**ADDENDUM
NO. 2**

November 3, 2022

**LIBERTY ELEMENTARY SCHOOL RENOVATIONS
Chesterton, IN 46304**

This Addendum consists of Pages ADD 2-1 through ADD 2-3 and attached Addendum No. 2 from Gibraltar Design dated November 2, 2022 and consisting of 7 pages, Specification Section 08 33 00 - Rolling Doors and Grilles, and 41 Drawings.

© GIBRALTAR DESIGN SHEET
A MD101

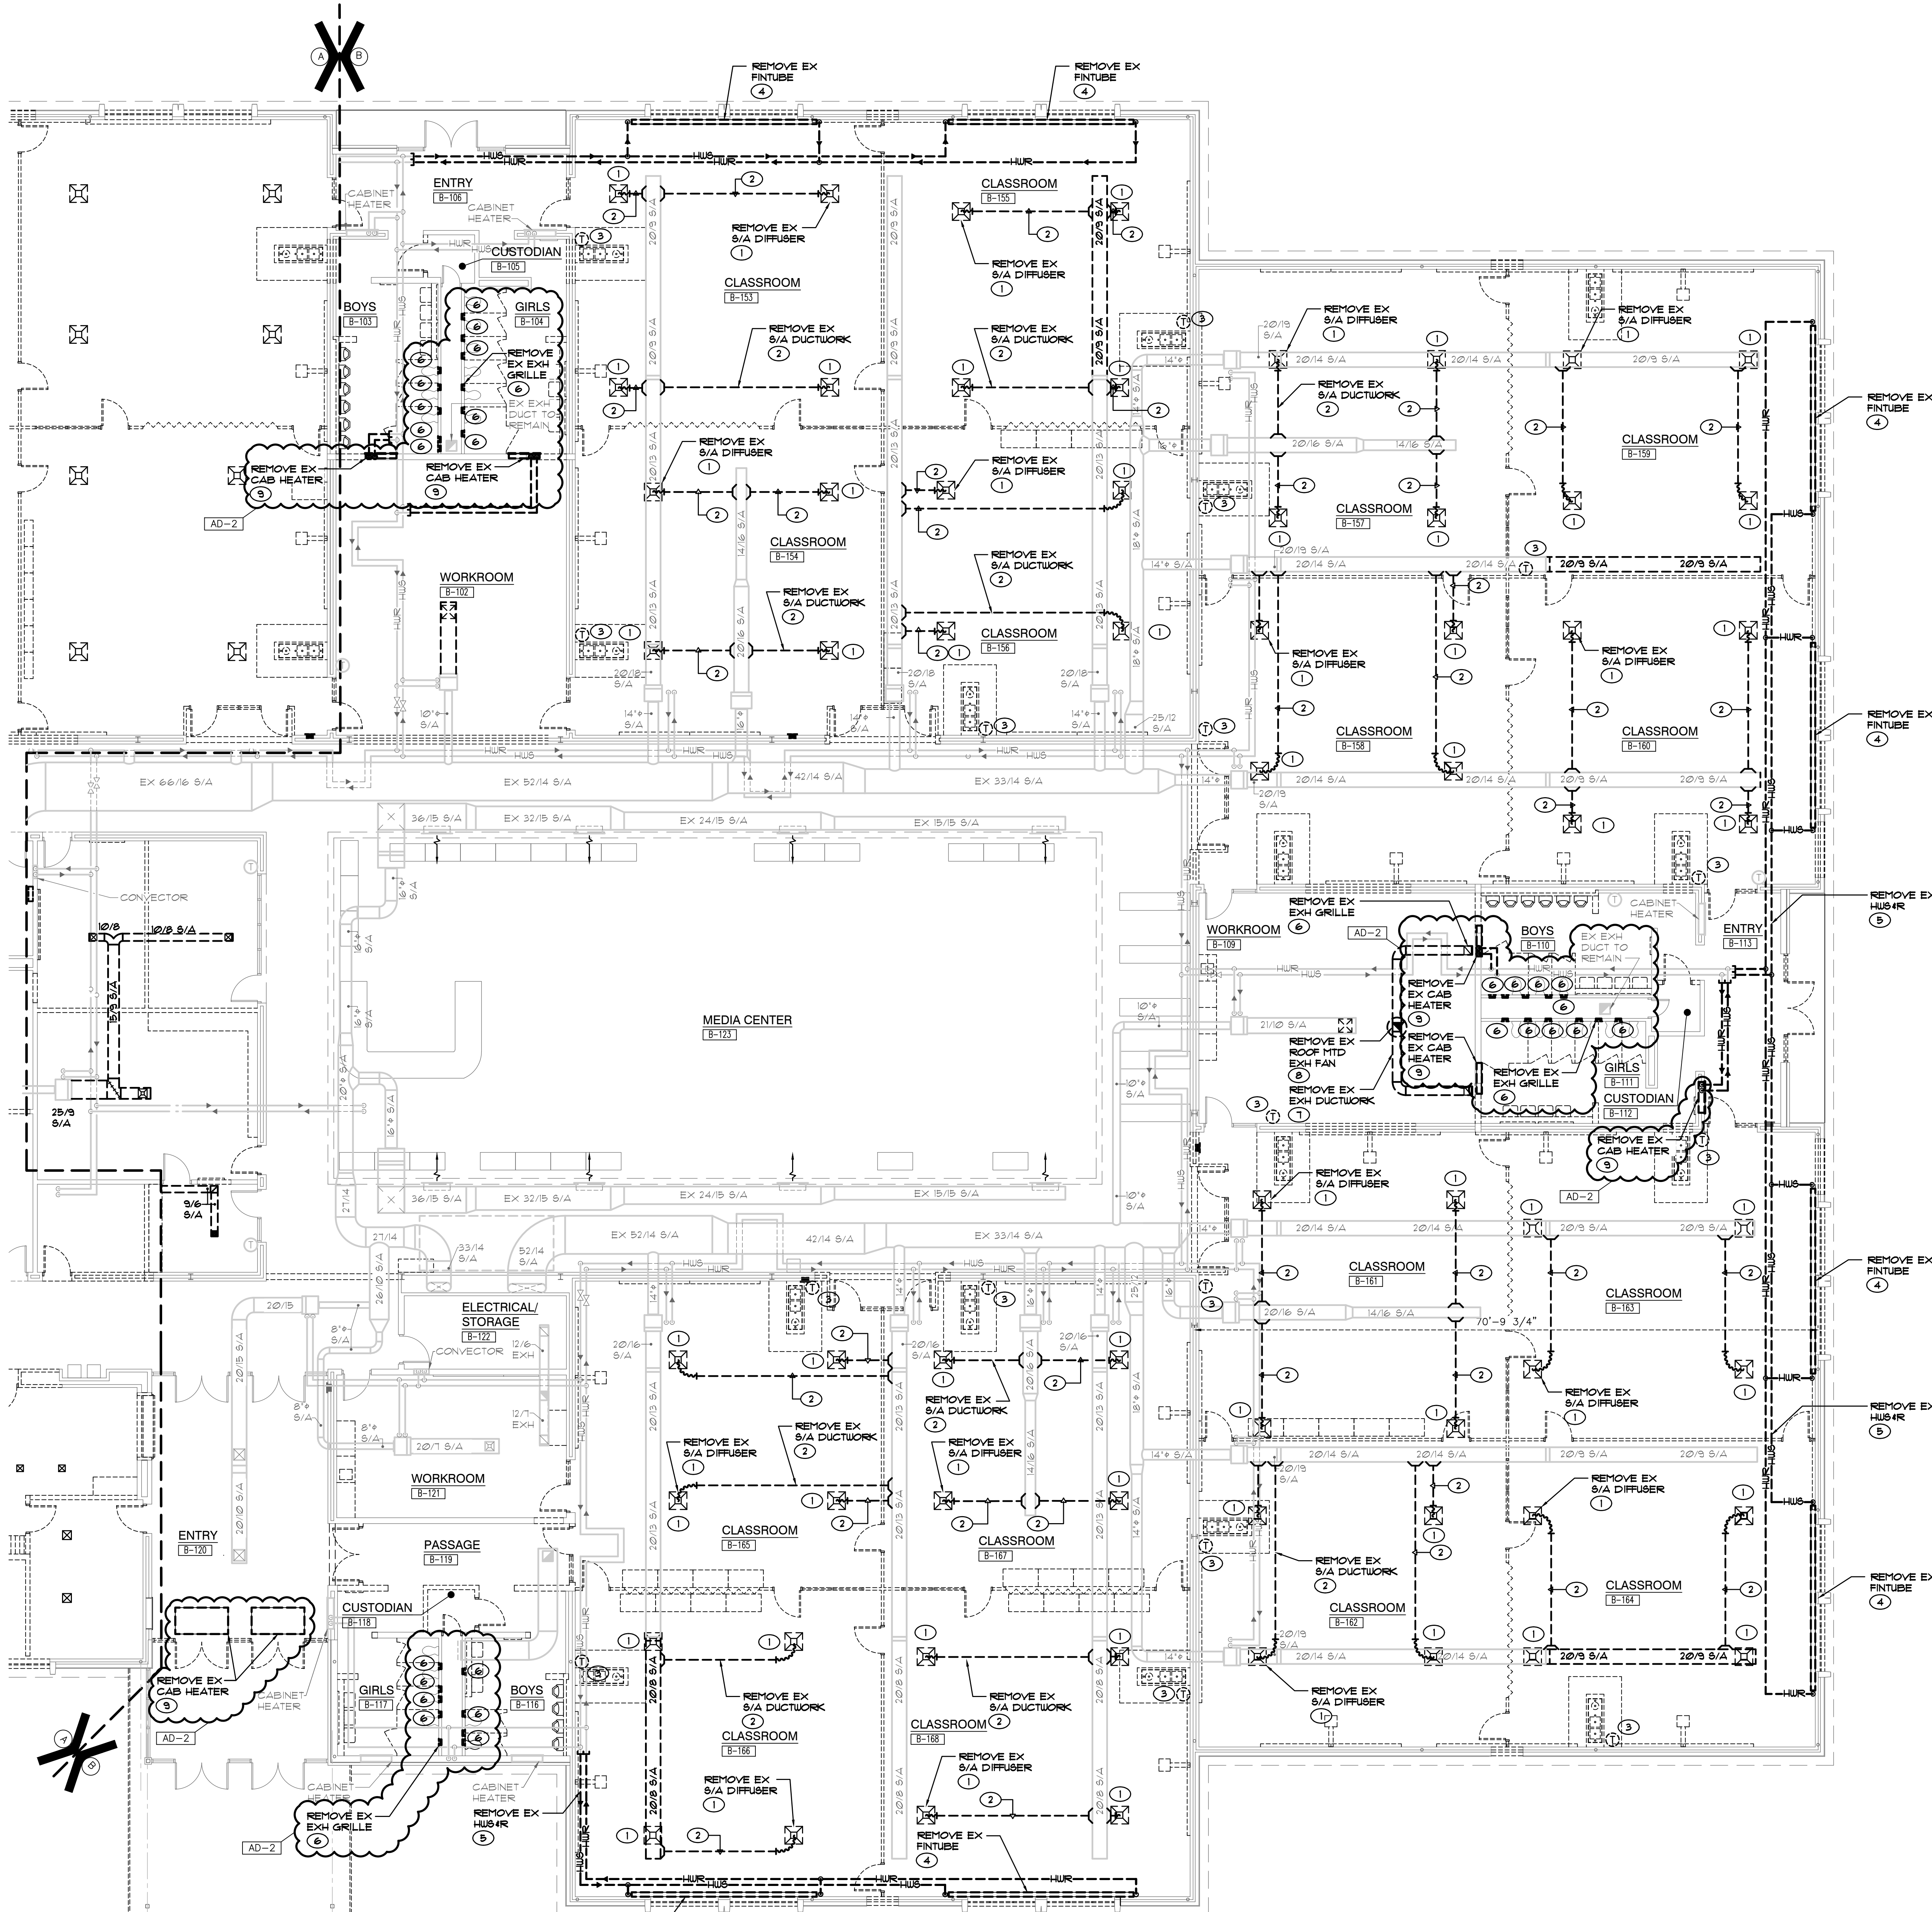
26. Sheet MD101

- A. Refer to revised full size drawings, included in this Addendum, for the following revisions:
 - 1. Added note to remove exhaust grilles from toilet rooms.

© GIBRALTAR DESIGN SHEET
B MD102

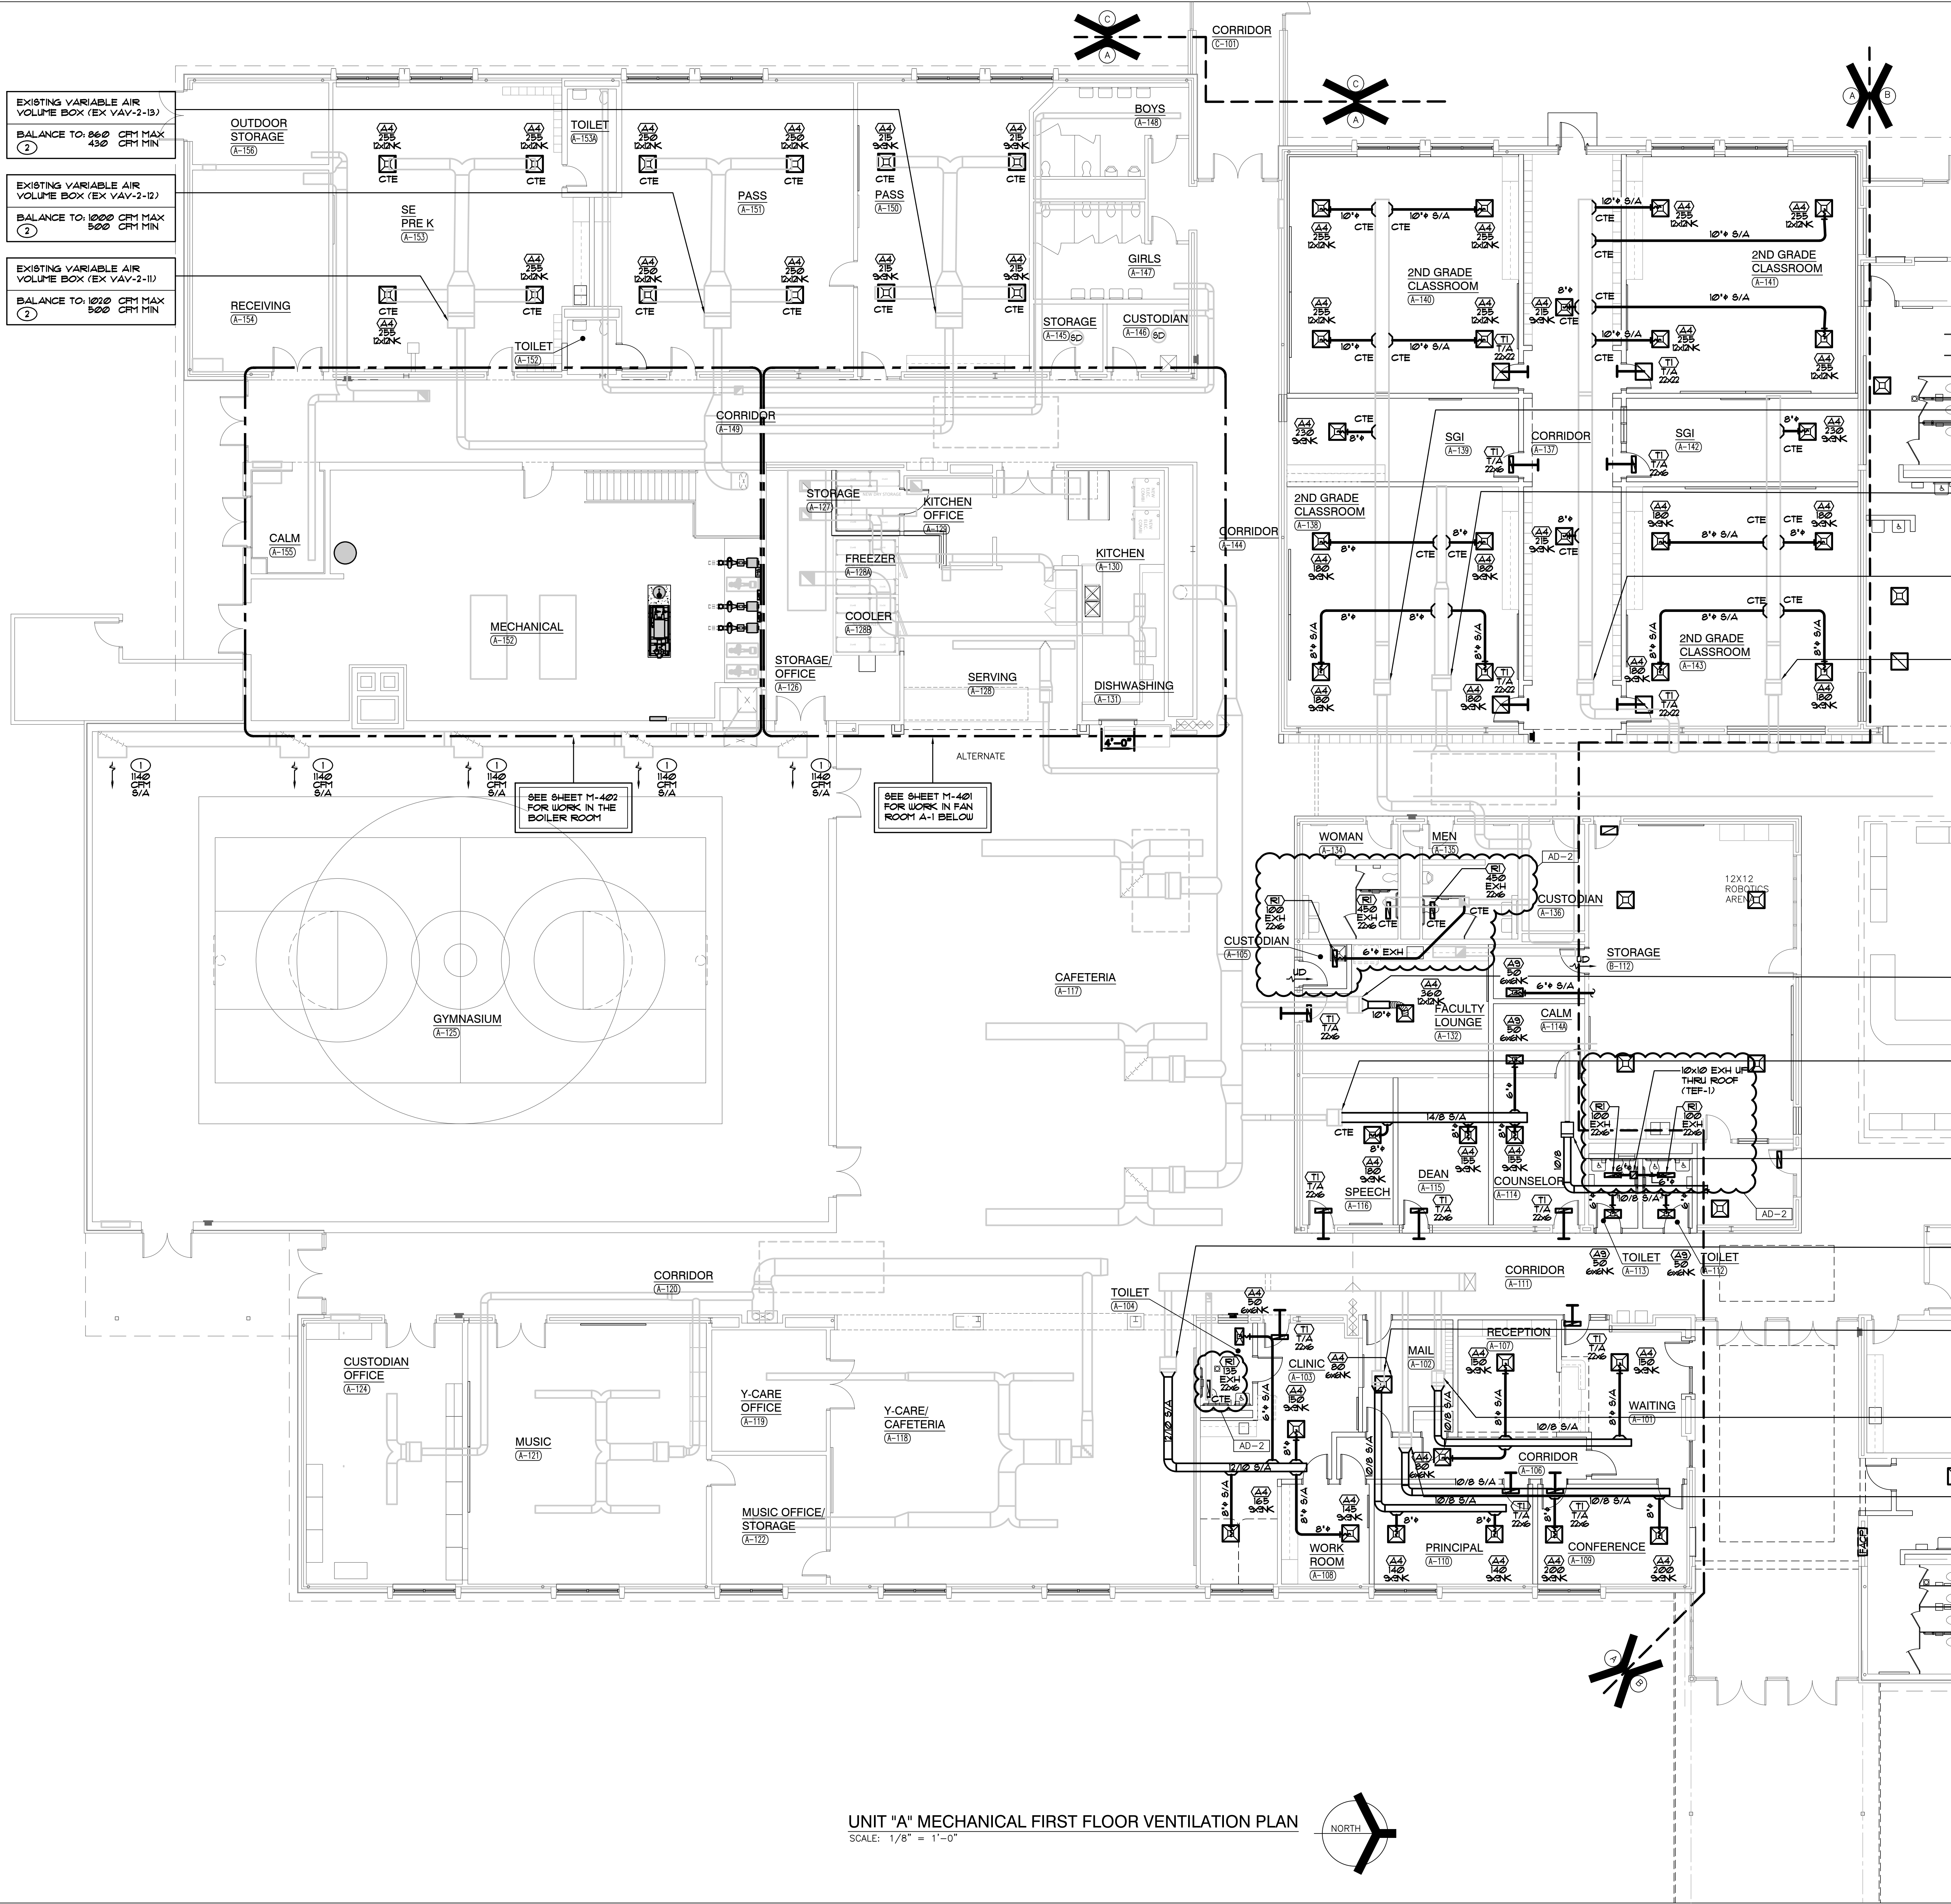
27. Sheet MD102

- A. Refer to revised full size drawings, included in this Addendum, for the following revisions:
 - 1. Added note to remove exhaust grilles from toilet rooms.
 - 2. Added note to remove existing cabinet heaters.

© GIBRALTAR DESIGN SHEET
B MV102

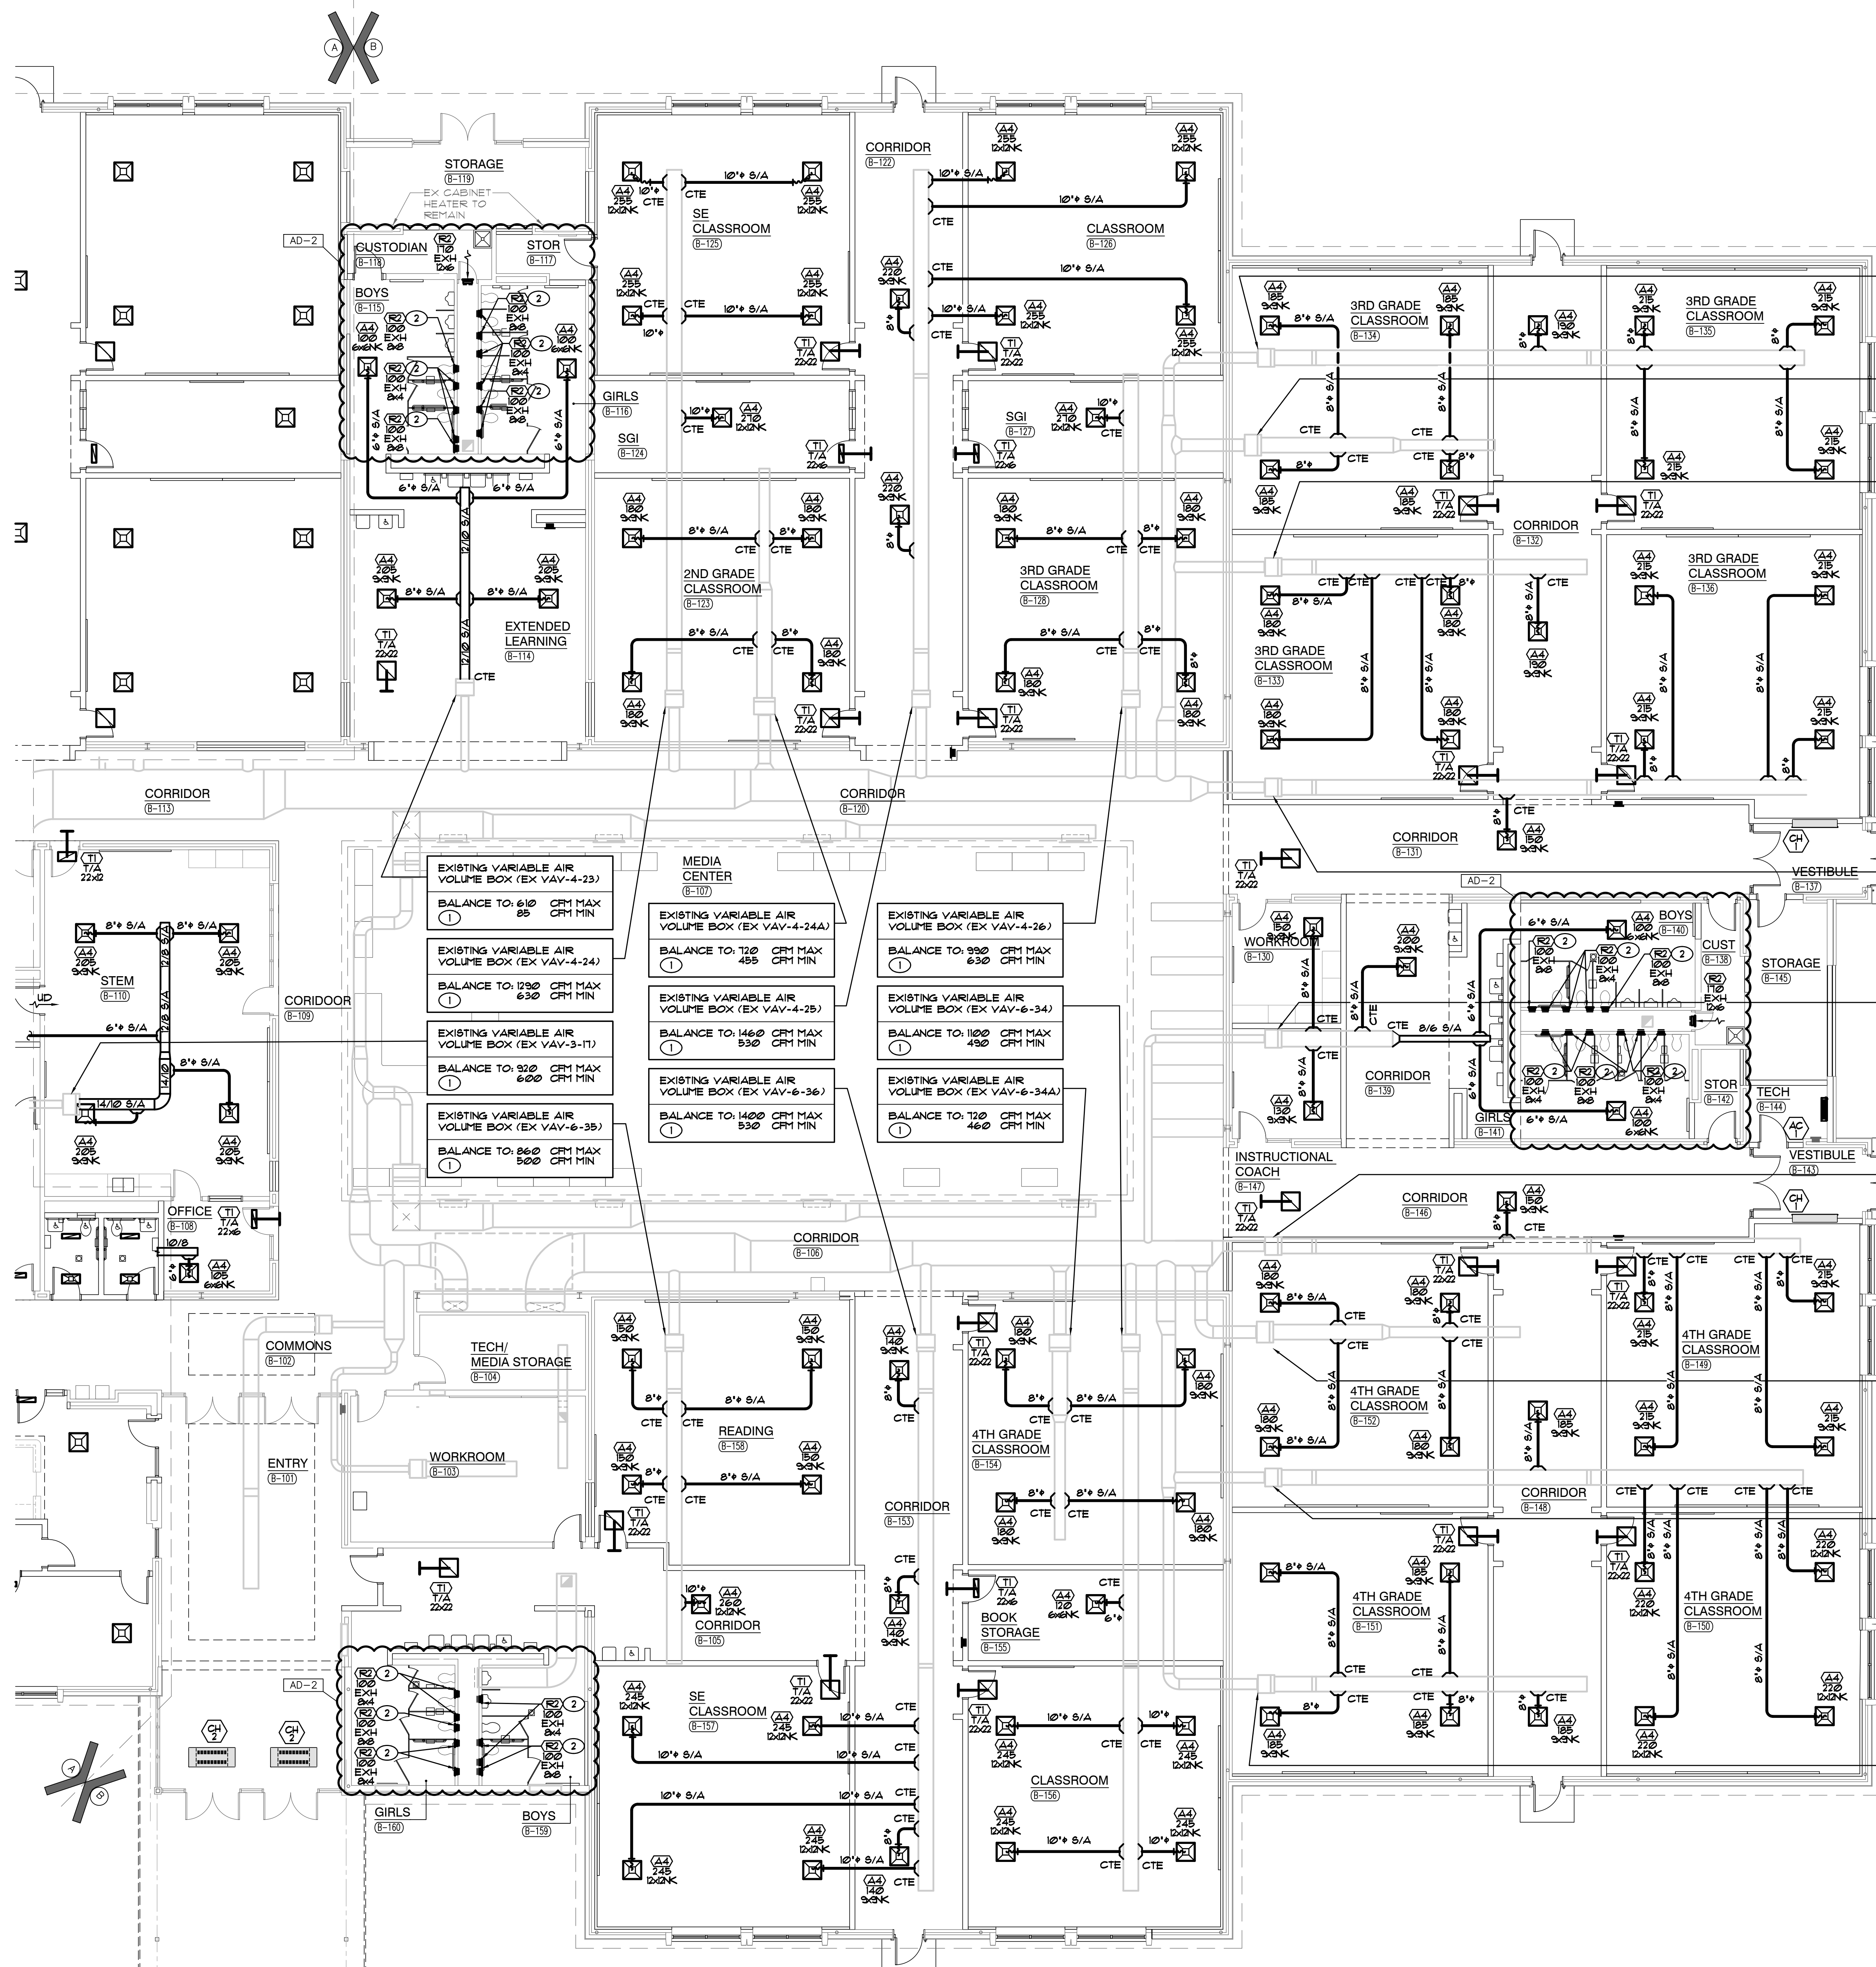
29. Sheet MV102

- A. Refer to revised full size drawings, included in this Addendum, for the following revisions:
 - 1. Added new exhaust ductwork and grilles from toilet rooms.
